Waikato District Council
Attention: Milan Covic
Milan.Covic@waidc.govt.nz

17_147

68-72 GREAT SOUTH ROAD, POKENO – TRANSPORT PEER REVIEW ADDENDUM

Figure 7: Proposed Vehicle Crossing Dimensions (Drawing 2998-B03, Rev F)

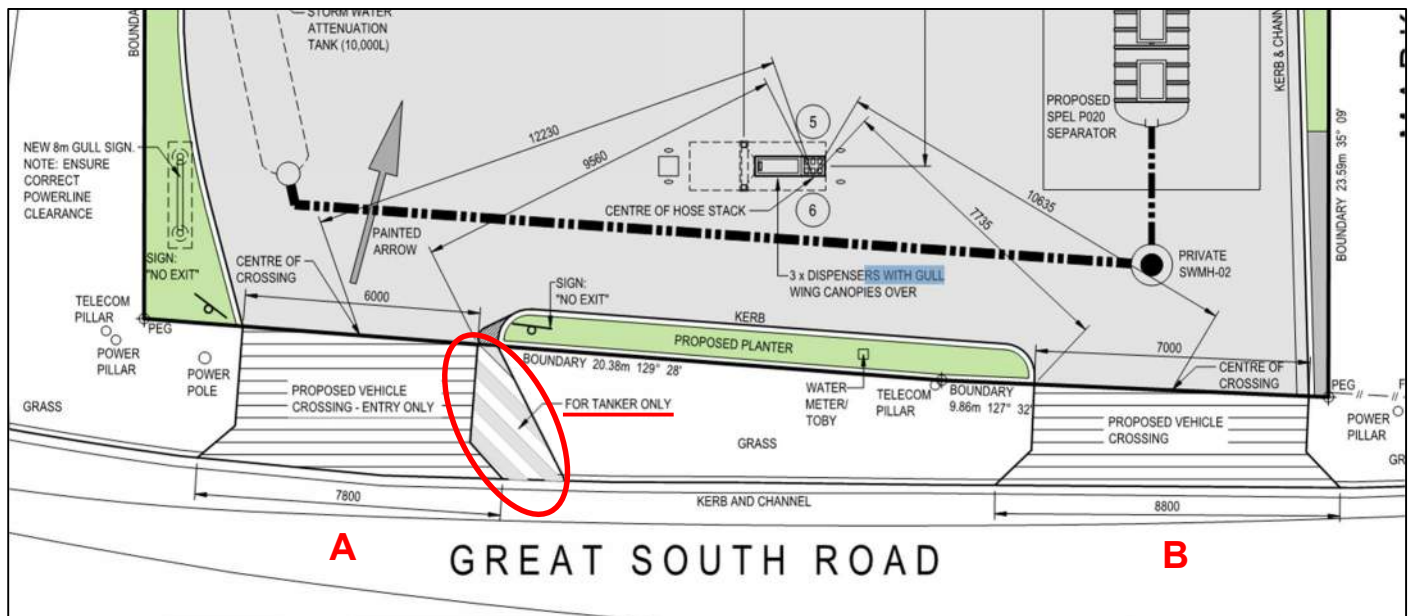
The ODP allows for a maximum crossing width of 6.0m at the boundary and 7.0m at the kerb. Crossing A is 6.0m wide at the boundary and 7.8m wide at the kerb. If the additional widening (to accommodate the swept path of the fuel delivery tanker) is included, the crossing is 6.5m at the boundary and 9.4m at the kerb. Crossing B is 7.0m wide at boundary and 8.8m wide at kerb.

As shown below in Section 4.3.3 there is limited sight distance for vehicles exiting crossing A. The proposal includes signs and markings to reinforce crossing A as “Entry Only”. However, we are concerned that the wide crossing may encourage vehicles to exit at crossing A, because it appears wide enough for two-way use, and vehicles may enter the site at higher than appropriate speeds—increasing the risk of vehicle-vehicle conflict at the crossings.

Figure 9: Possible Vehicle Crossing Configuration, Showing Delineation of Proposed Crossings (Drawing 2998-B03, Rev F)

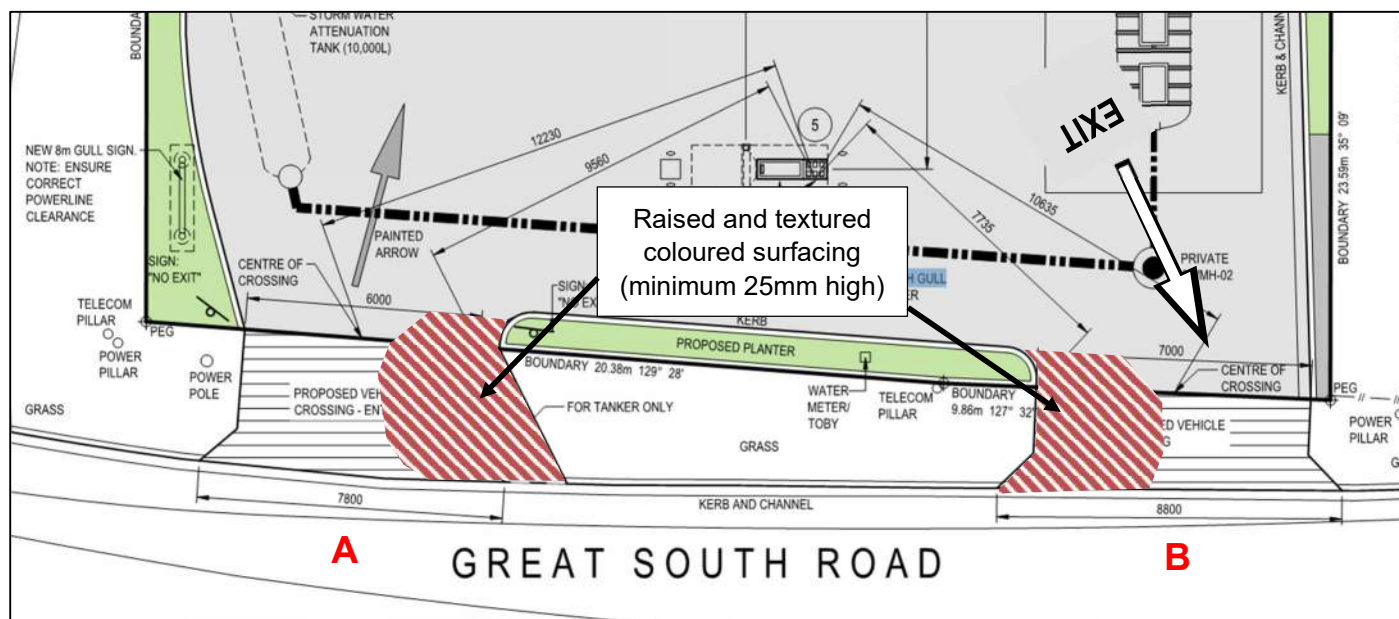
We consider it likely that the site will operate with predominantly one-way traffic flow – entry at Crossing A and exit at Crossing B. We suggest that Crossing B be signed and marked as “Exit Only” and treated with raised and textured coloured surfacing (minimum 25mm high) as recommended for Crossing A. This will improve flow on site and minimise the likelihood of vehicle-vehicle conflict.

Figure 10: Separation Distances to Existing Vehicle Crossings (marked yellow) and Intersections

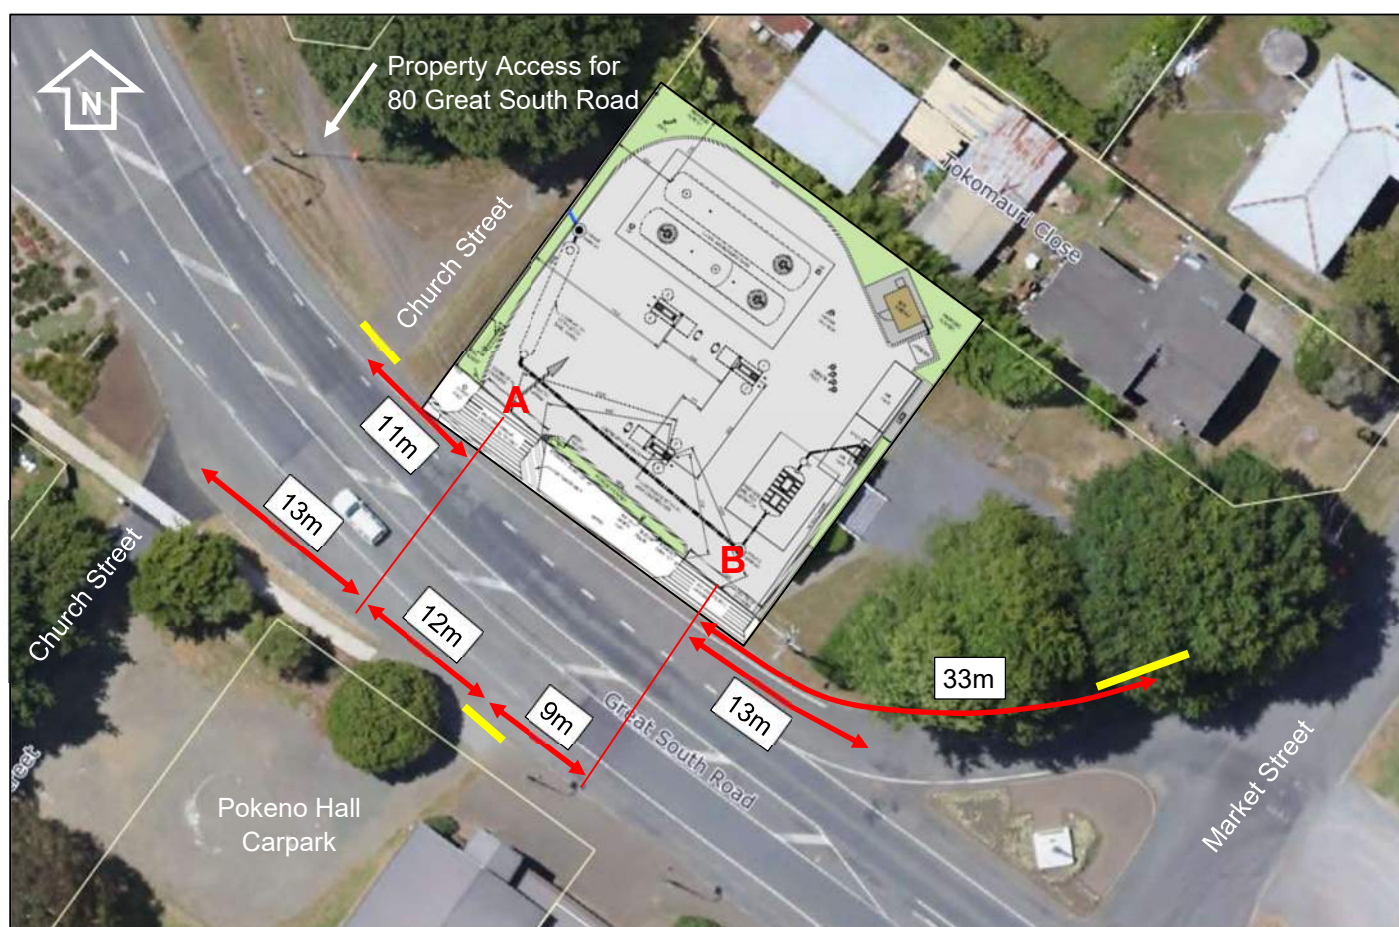
Table 9.B⁵ of the ODP specifies the minimum distance between crossings as 15m and requires 20m on the approach to a side road, or 30m on the departure from a side road. Table 14.12.5 of the PDP sets out the separation distances based on road hierarchy, being 15m between crossings and 30m to a side road for a collector or local road.

The proposed vehicle crossing locations do not satisfy the separation distance requirements of the District Plans. The separation distance to Pokeno Road and Market Street are satisfactory. However, we note that

Figure 11: Possible Slip Lane Closure Option for Future Pokeno Streetscape Upgrade/Market Square Development

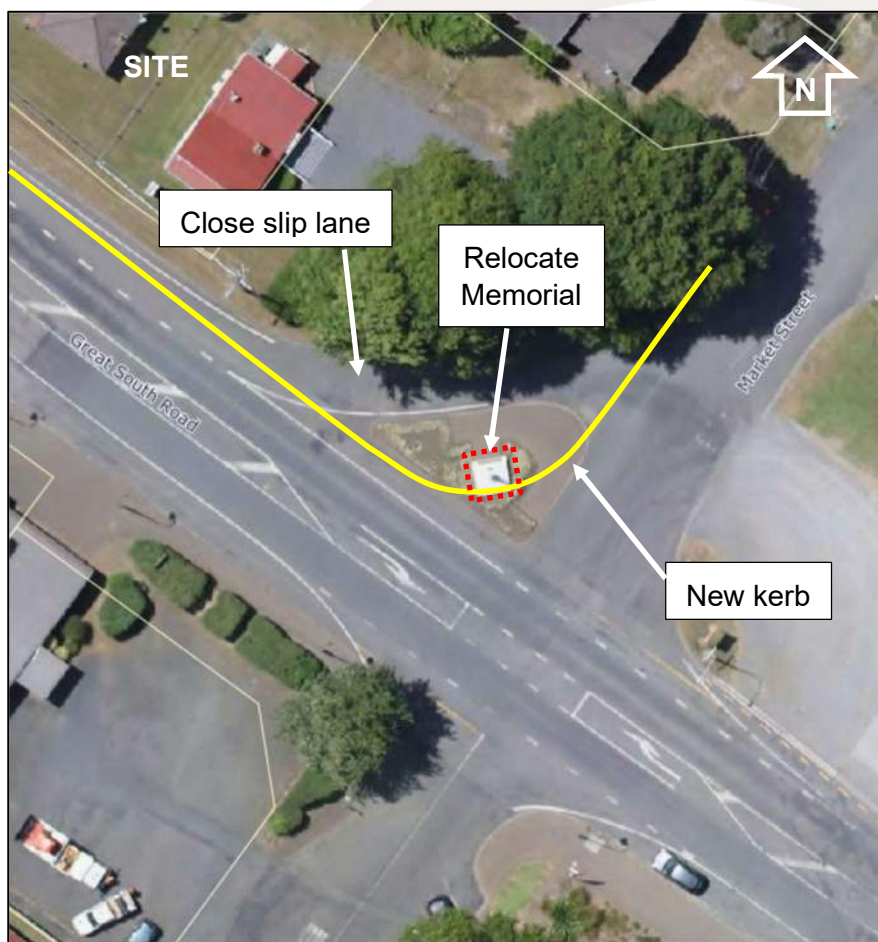
It does not appear necessary to have a left turn slip lane in this location. If the memorial was relocated the slip lane could be closed and the kerb realigned to provide a standardised cross-roads intersection, consistent with the scale and form of other intersections in the town centre. This would simplify the intersection form, reducing the number of conflict points, improve pedestrian safety and enhance the public space.

We suggest that Council considers relocating the memorial and simplifying the Market Street intersection as part of any town centre streetscape works, irrespective of the proposed development at 72 Great South Road.

Figure 15: Roadside Vegetation (image: Google Street View, April 2012)

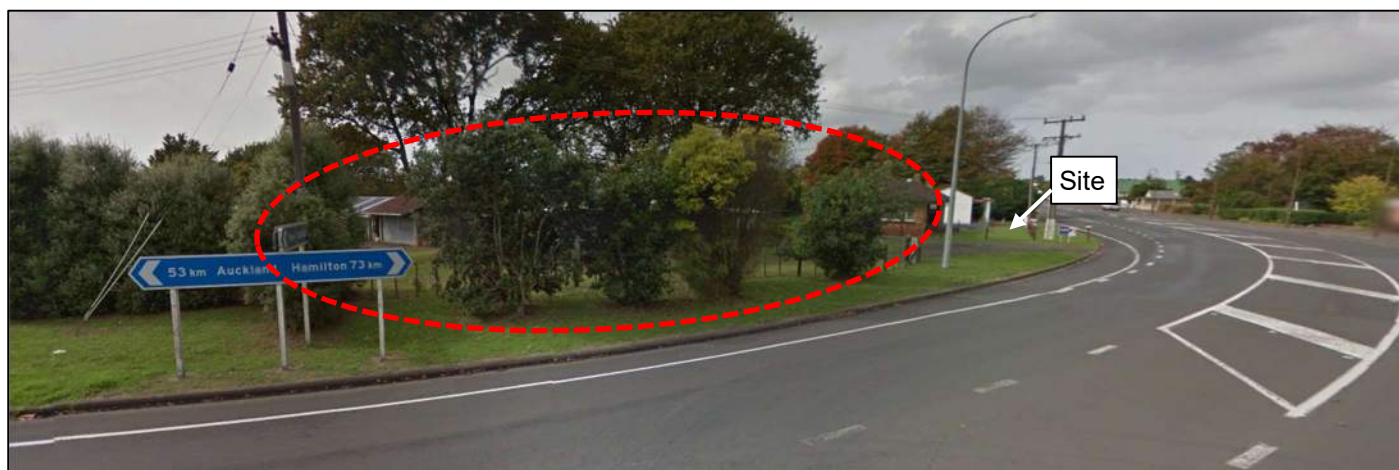
Note the vegetation located within the road reserve (circled red) had no foliage at the time of our site visit and does not currently obscure sight distance. If these trees grow foliage, they are likely to block sight distance.

Figure 18: Sight Distance Requirements for the Proposed Vehicle Crossings

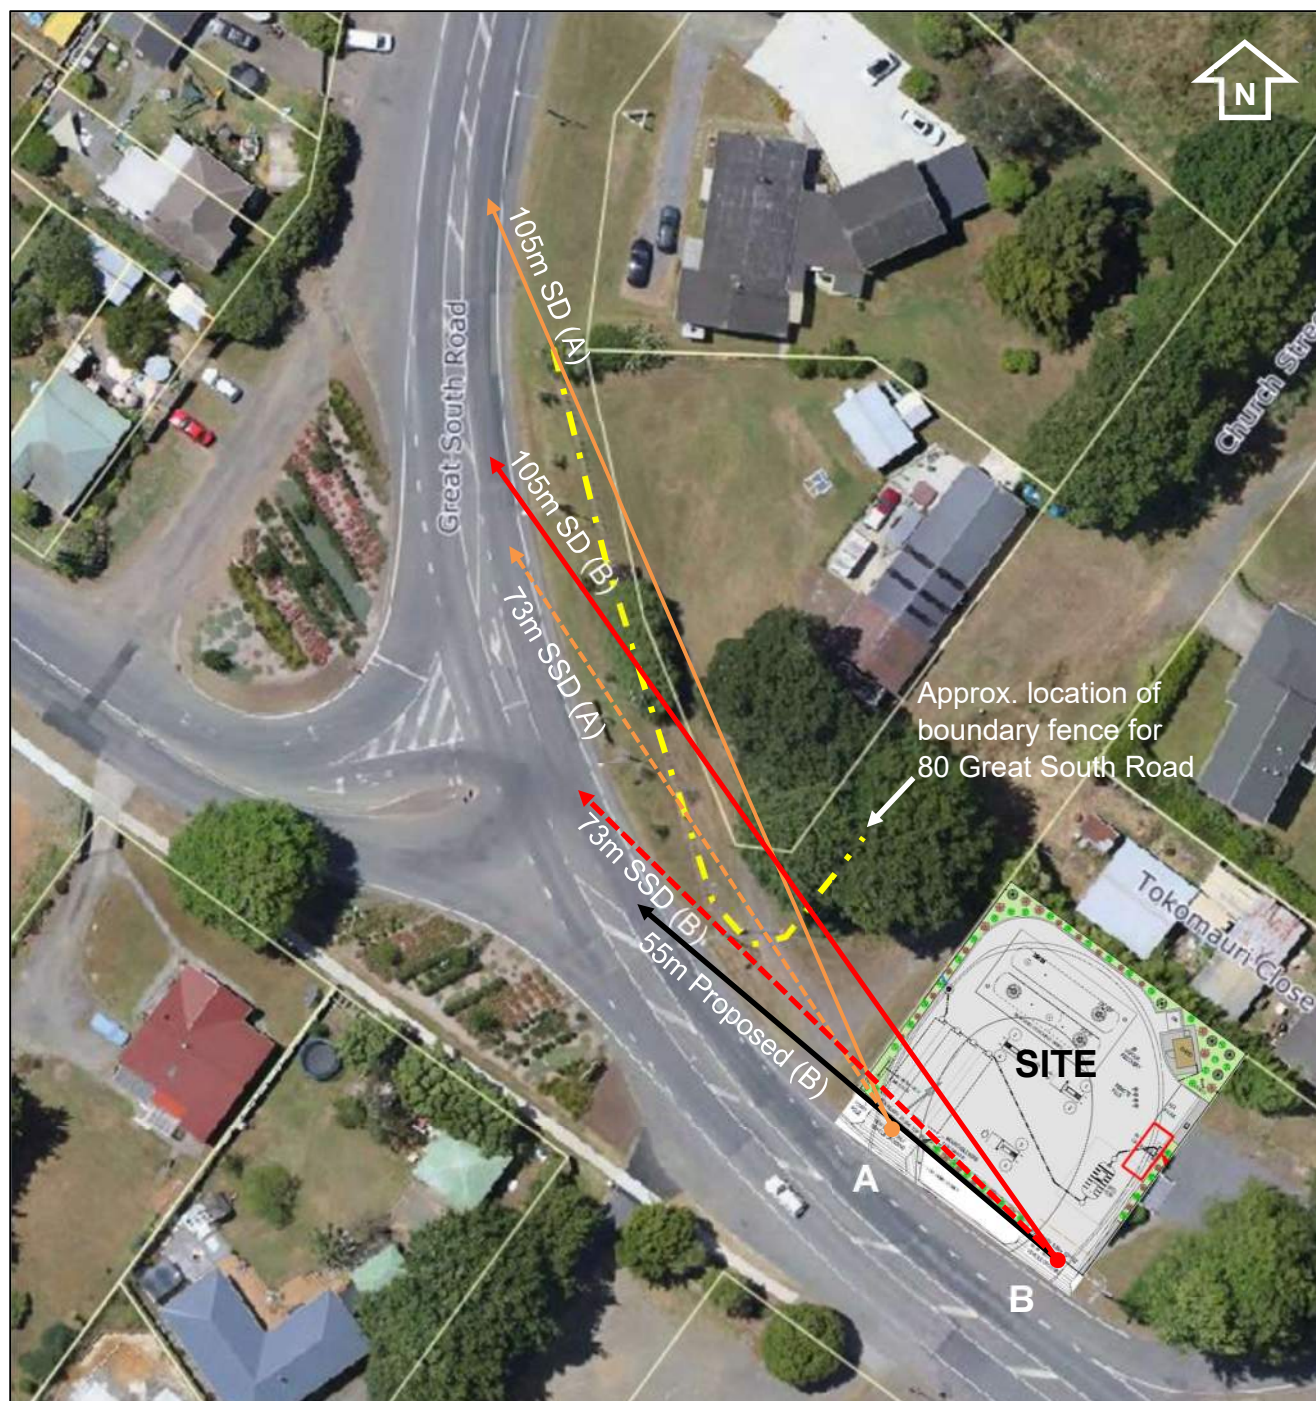
Sight distance to the south (looking left) from both proposed vehicle crossings is in excess of 150m and complies with the requirements of the ODP. Neither of the proposed crossings has sufficient sight distance to the north (looking right). The available and required sight distances are shown in the figure below.

Crossing A does not provide the required 105m of unobstructed sight distance to the north. However, the proposal is for this vehicle crossing to be marked as Entry Only (no exit). The sight distance required for an entering vehicle is the stopping sight distance as measured from the position of a right-turning vehicle waiting on the flush median (Austroads⁷).

Figure 20: Landscaping Plan and Plant Schedule, Showing Sight Lines from Figure 18 (Drawing 2998-B01, Rev A)

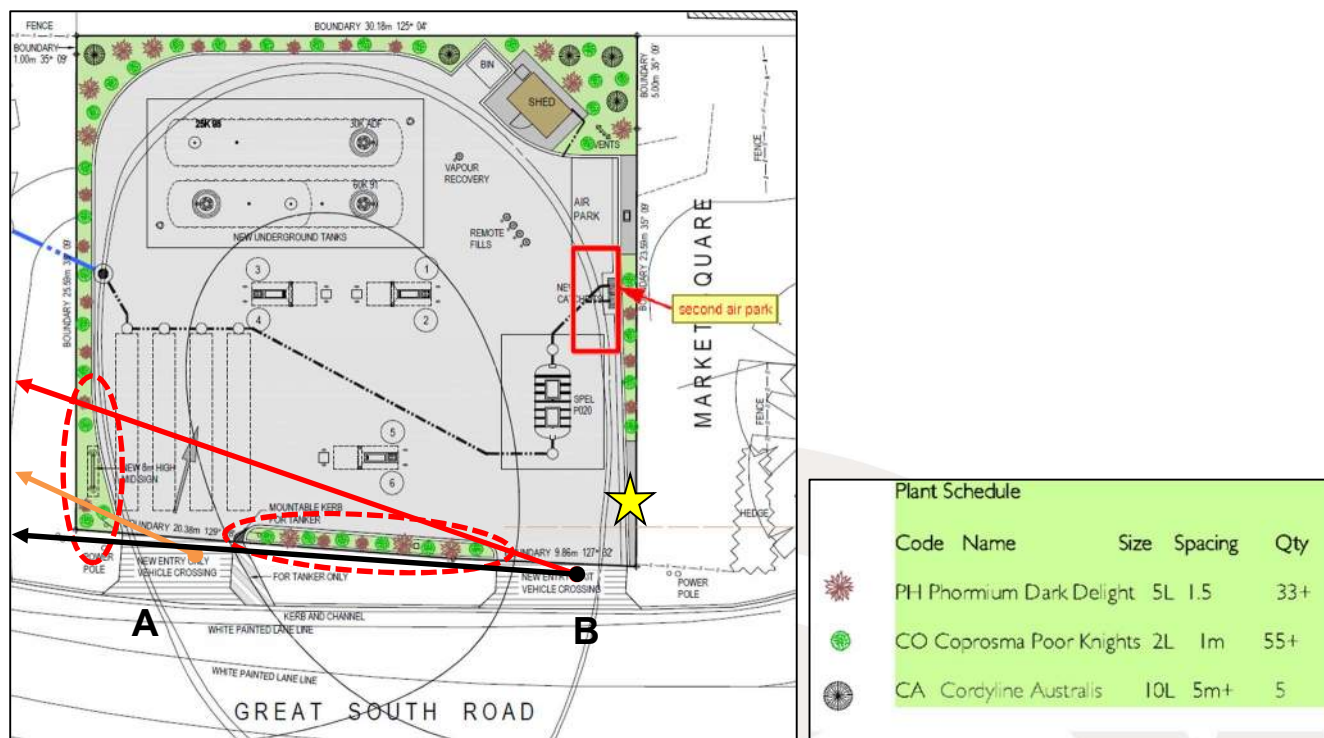
The supplied plans indicate the site will have screening planting along the Great South Road frontage and the western boundary with the unformed section of Church Street. These plantings could grow in excess of 1m high and obstruct sight distance from the vehicle crossings, reducing the available sight distance to about 55m (refer Figure 18). If there was no screen planting within the site, the shortfall in sight distance would be unchanged as the roadside vegetation and fence at 80 Great South Road would still block the sightlines. (As mentioned above the sightline within the road reserve is about 10m short of that required by the District Plan for an operating speed of 60km/h)

We recommend no screening planting is used in the areas circled red in the figure below and that any planting in these areas is maintained to a low height or limited to ground cover plants only. The planting within the site will need to be maintained to ensure sight distance for crossing B is not obstructed.

Figure 21: Proposed Sign (Drawing 2998-09, Rev B)

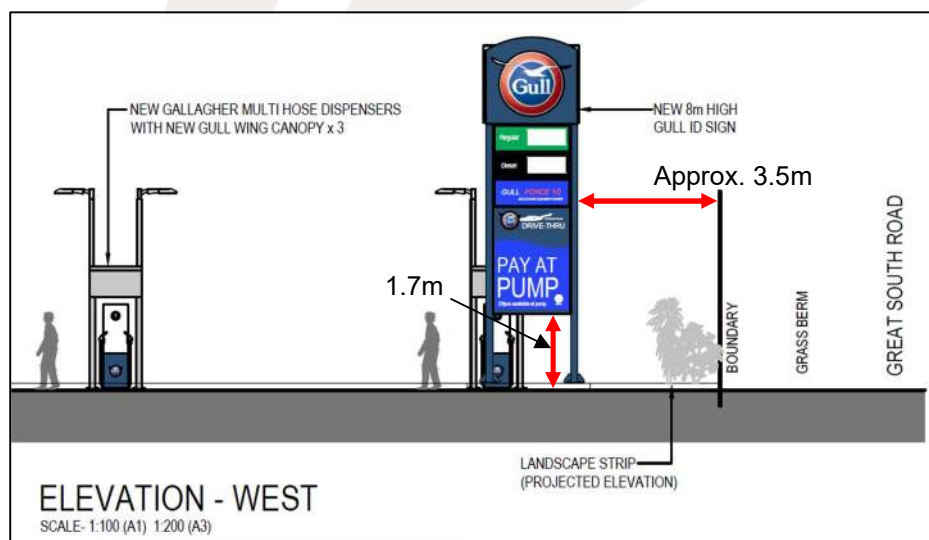
The proposed Gull ID sign is located near crossing A, approximately 3.5m from the boundary with Great South Road. The location of the sign obstructs sight distance for drivers exiting crossing B. We recommend the sign be relocated to the southern boundary (as indicated by the yellow star in Figure 20 above) to ensure sight distance for crossing B is maximised and unobstructed.

Figure 22: Queuing Diagrams (from TIA Figure 7 and 8)

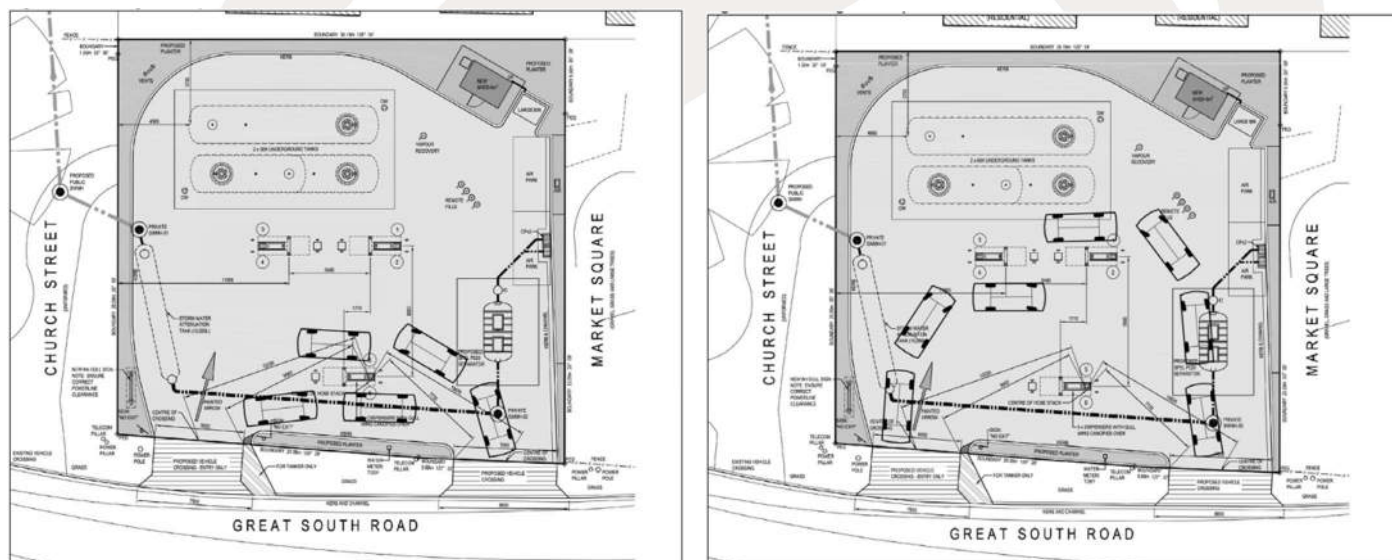
The TIA indicated there is enough queuing space on site for about 11 light vehicles. However, we note that the queuing vehicles may obstruct the vehicle crossings, making it difficult for a vehicle to exit when other vehicles are queuing, particularly when the fuel delivery tanker is on site. Congestion on-site may increase the likelihood of vehicles exiting via Crossing A.

The trip generation estimation indicates the six pumps will be required to serve up to 60 tph. This equates to approximately five vehicles per pump and an average visit duration of 12 minutes per vehicle if no queuing is to occur. This appears to be a reasonable rate of turnover for a service station and given the capacity for some on-site queuing.

Figure 23: Swept Path of Quad-Axle Semi-Trailer Tanker Right Turn Entry and Exit (from TIA Figure 5)

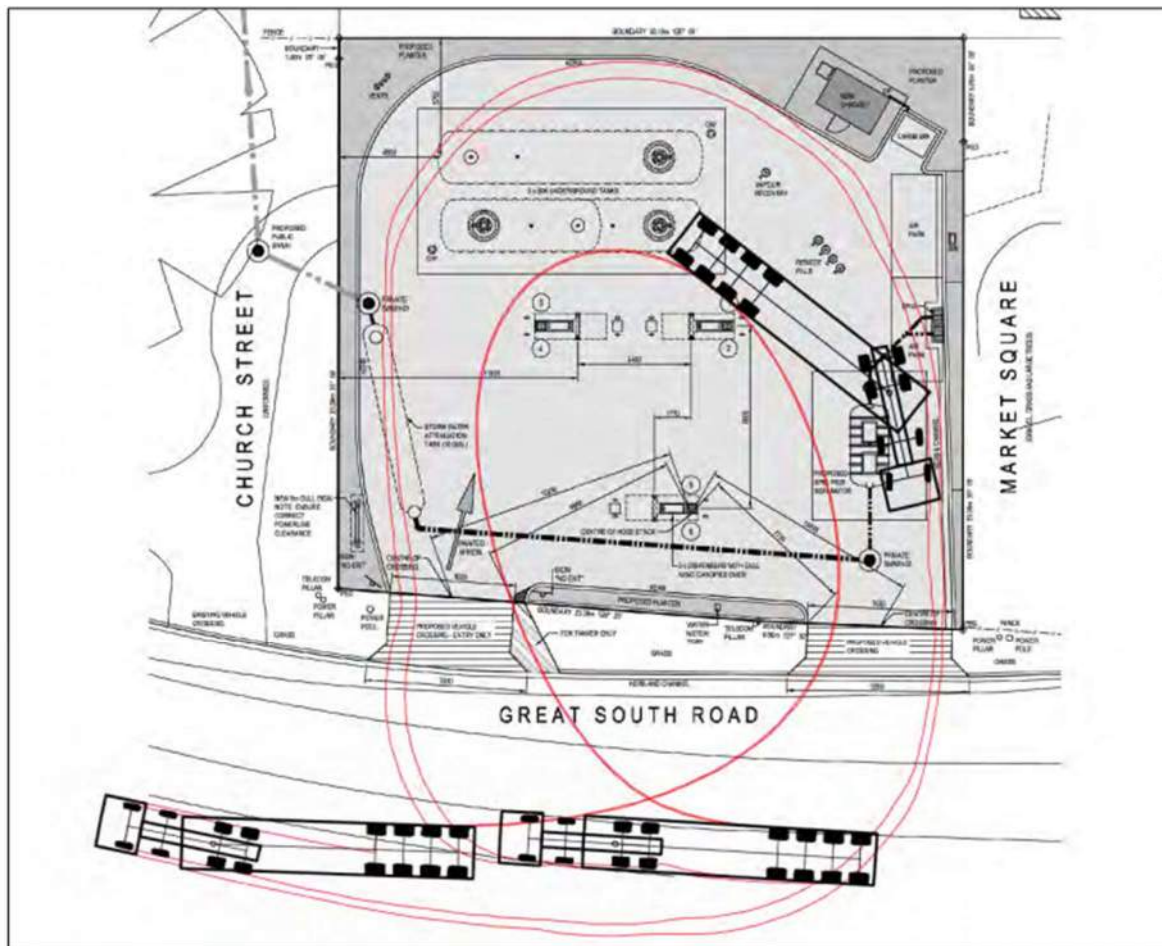
The figure above shows the use of additional widening to Crossing A to allow for the swept path of the tanker entering the site.
